Addendum 01

Project:	M&T Bank Stadium HVAC Controls, Lighting Controls and Submetering Systems Improvements	Date:	April 7, 2021
Subject:	Addendum 01	BKM Project No:	20092.01

The proposed additions, deletions, or modifications to the Bid Documents, dated February 12, 2021, are as follows:
Incorporate clouded revisions identified by a Delta 1, dated 04/02/2021.

DRAWING NO:
M1.12
BKM# 20092.01

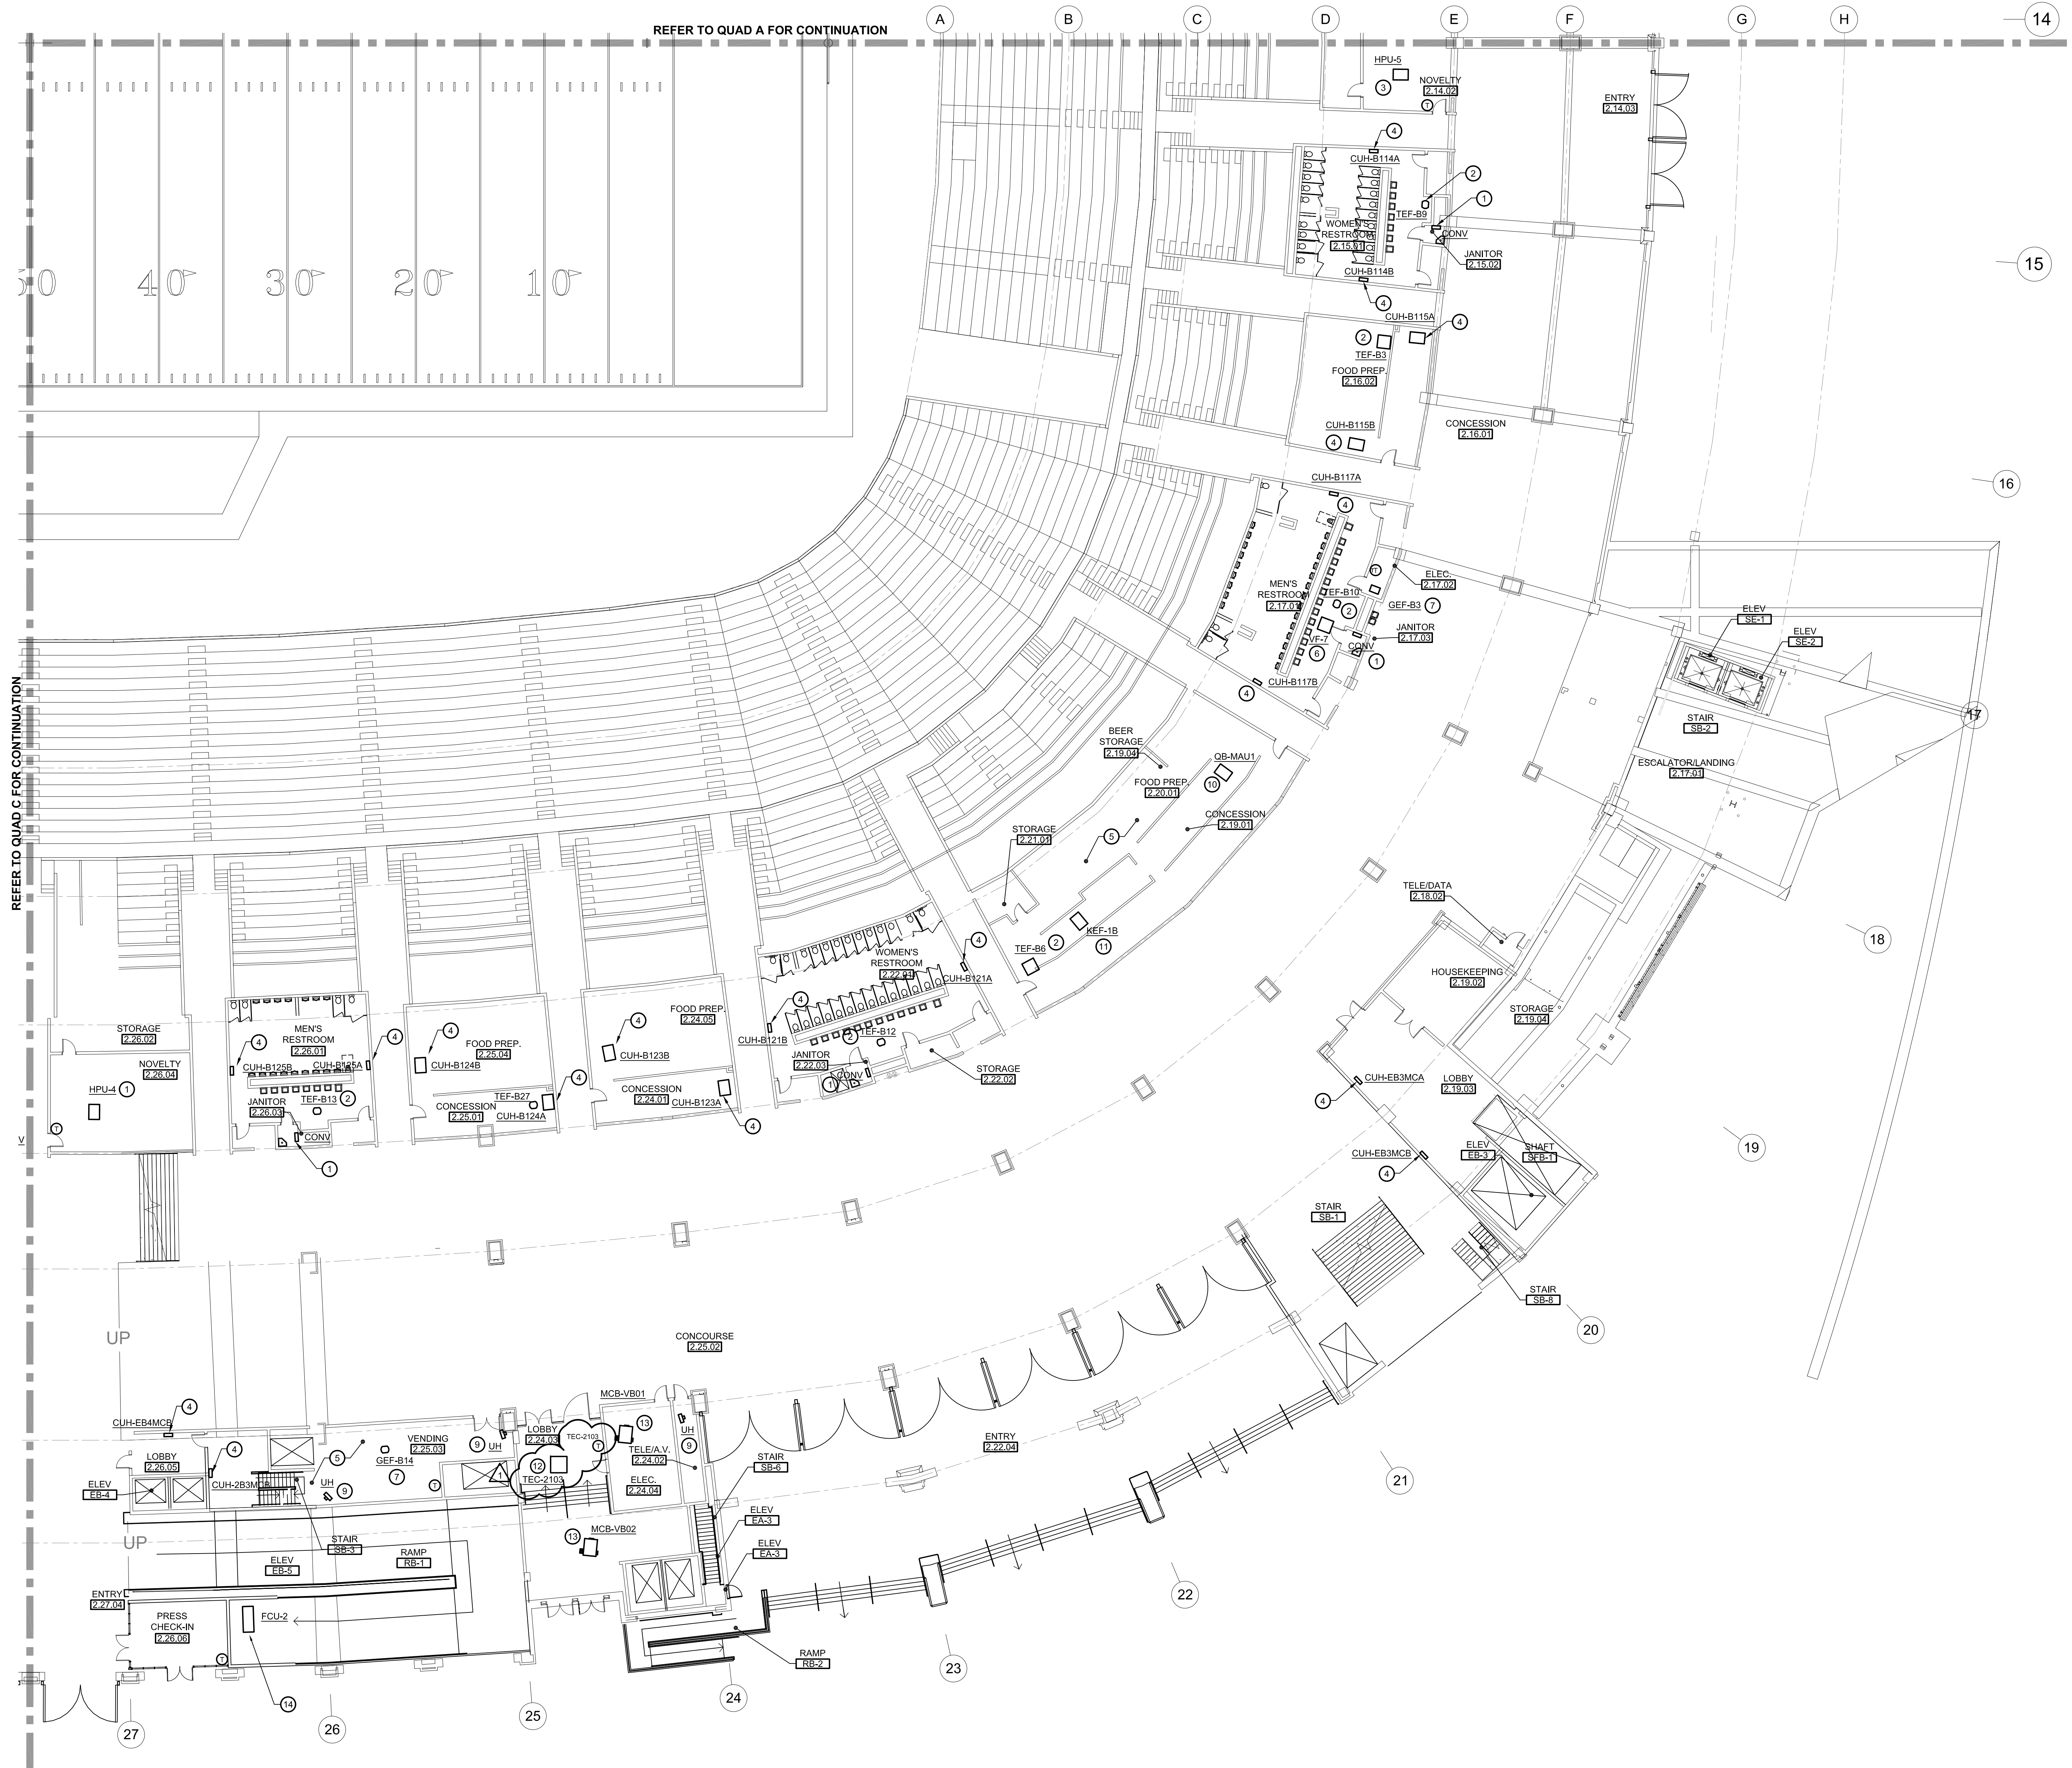
Drawing M1.12 – Main Concourse Lvl – Quad B – Mechanical - New Work:

- Added split system AC unit to the Lobby (per MSA's direction that there is an existing unit located here).

M2.02b

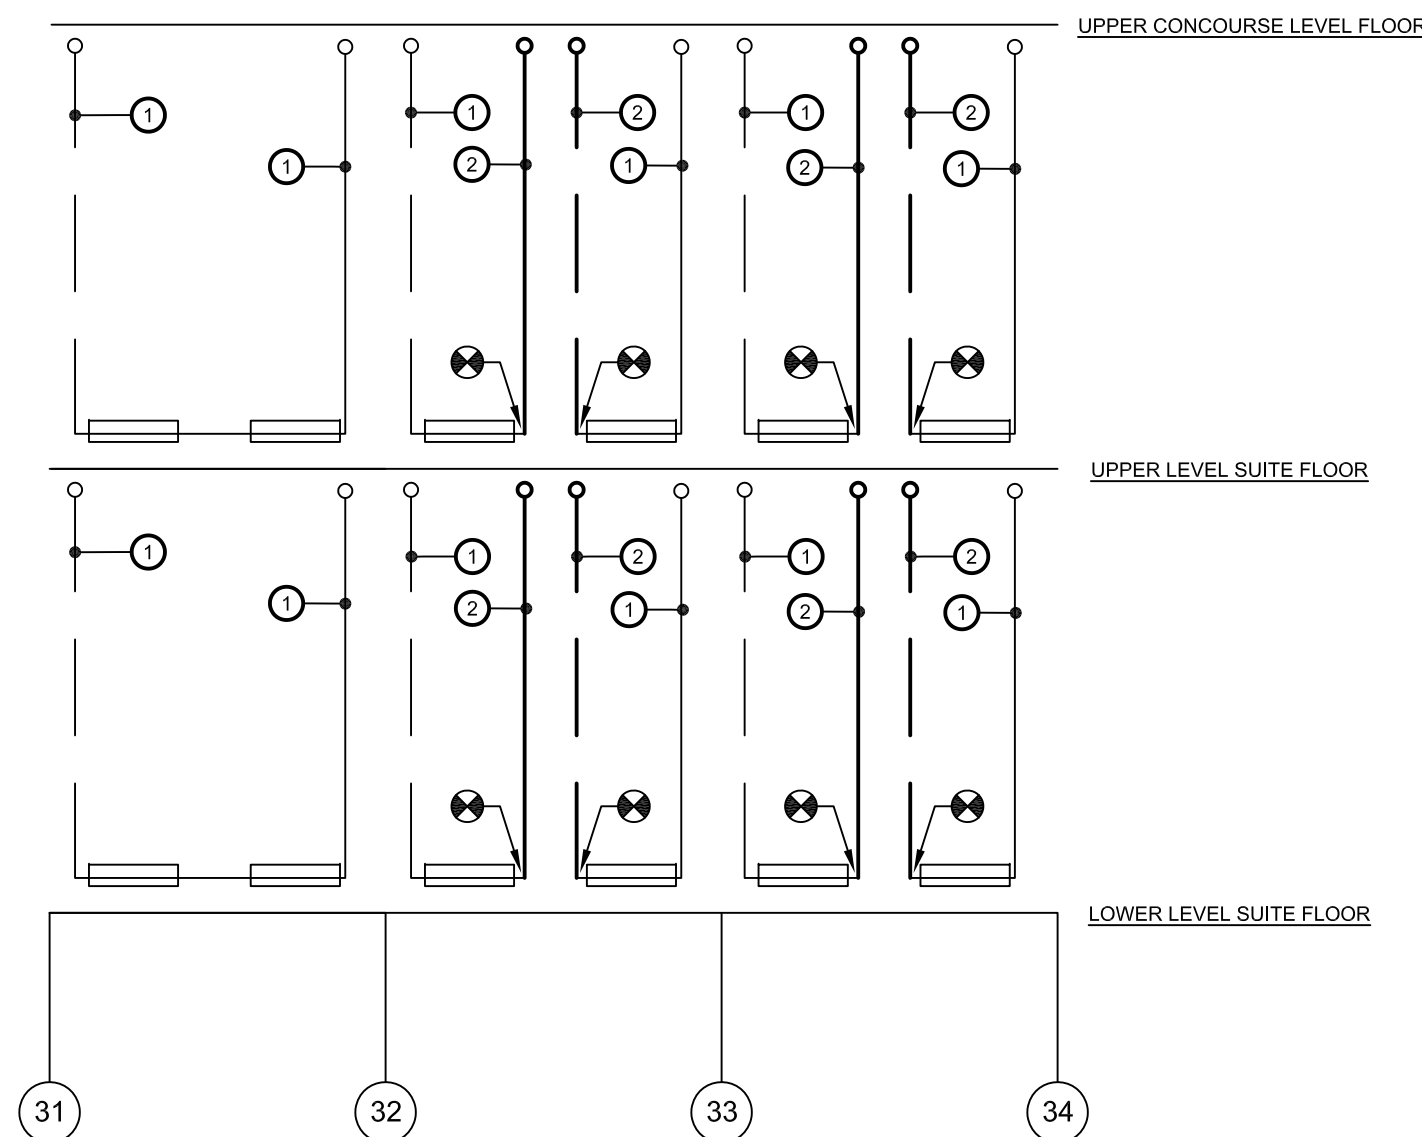
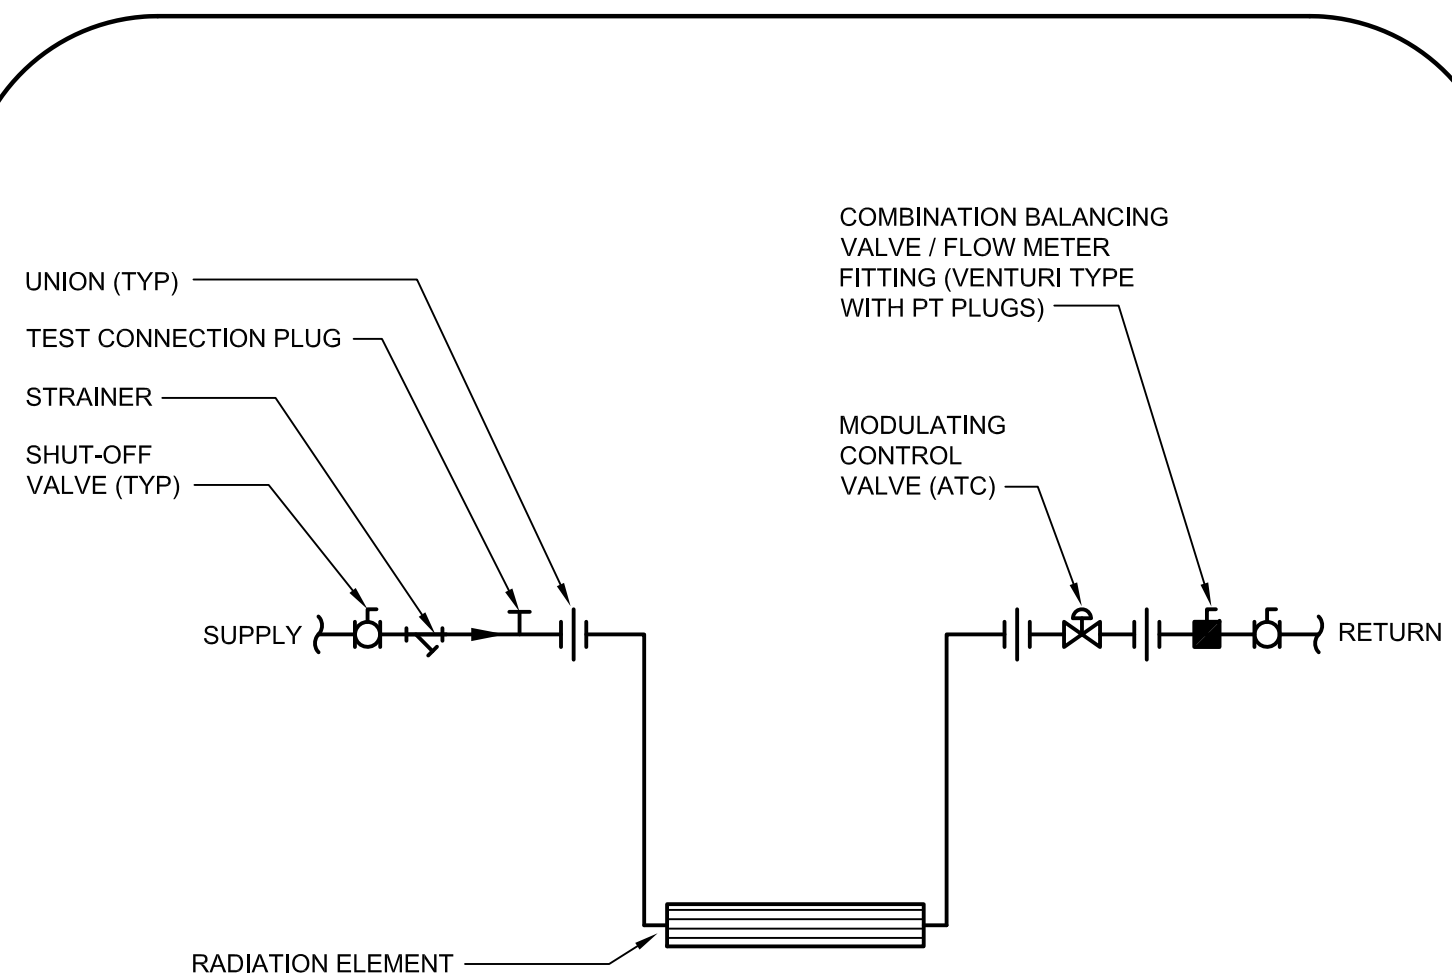
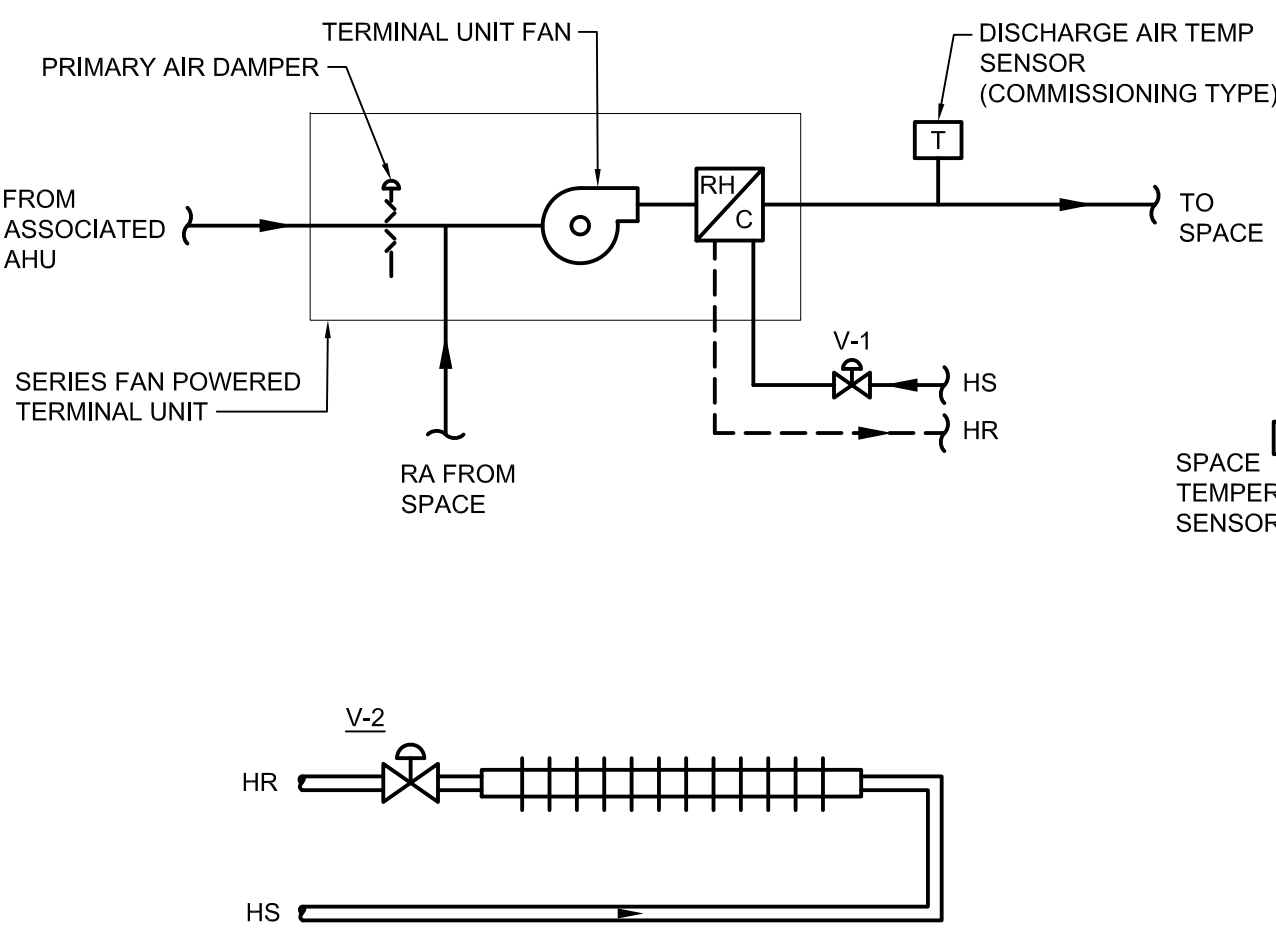
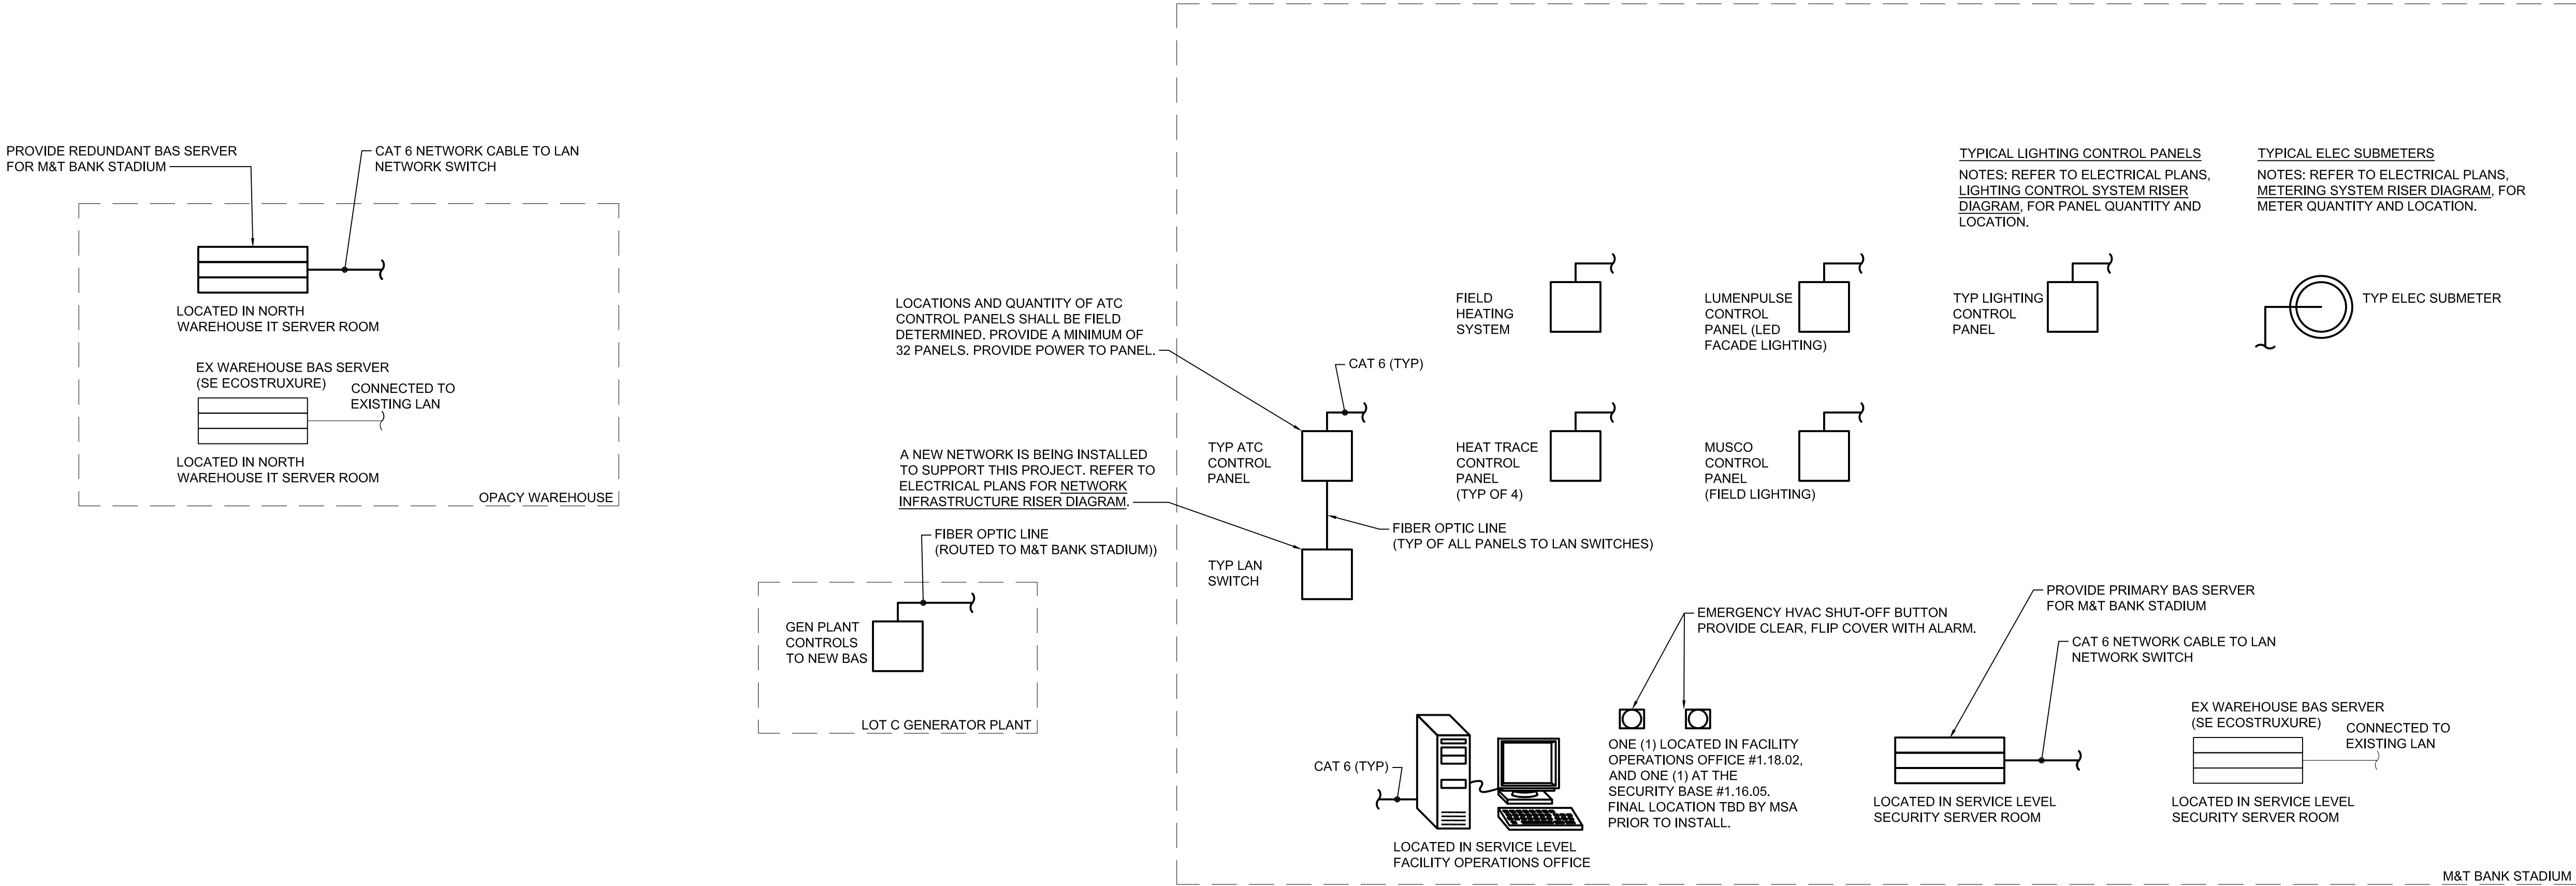
Drawing M2.02b – Raven's Office Schematics, Details and Controls:

- VAV and Radiator Control modified. Control modified to match Series Fan Powered Operation. Valve operation modified to open both valves for "warm-up" mode.
